# Access Compliance Report

### (Curb Ramps)

| Intersection ID: 16107                  | Main Street: QUEENS_RD_WEST | Cross Street: RADCLIFFE_AV              | Location: SE           |
| ADA ID: F13C4AD3D35A                    | Ramp Type: PerpDiag         | Initial Pass/Fail: Fail                 | Overall Compliance: No |

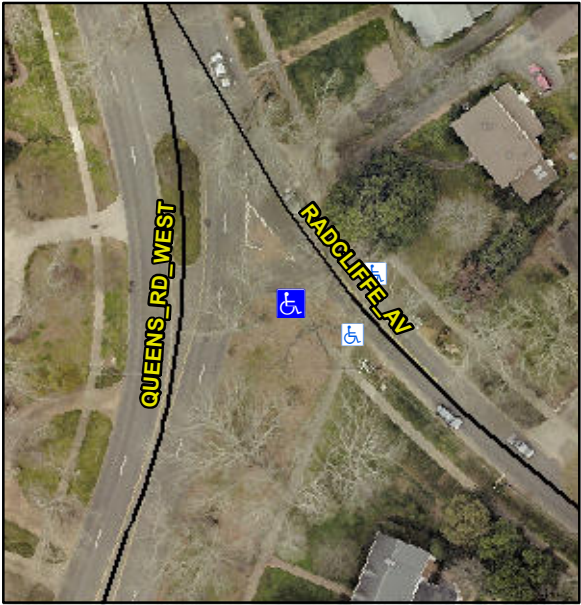
|  | Remove & Replace Curb Ramp With Two New Directional Ramps or Equivalent. |  | N/A        |  | Ramp Length (in)      |  | 89.0  | Yes        | Ramp Slope (%)              | 5.8  |
| <p>Surveyor Notes:</p> <p>N/A</p> <p>PROW/ADA:</p> <p>R304.5.1, R304.5.3</p>     |  |  | No         |  | Ramp Width (in)       |  | 43.0  | No         | Ramp XSlope (%)             | 7.4  |
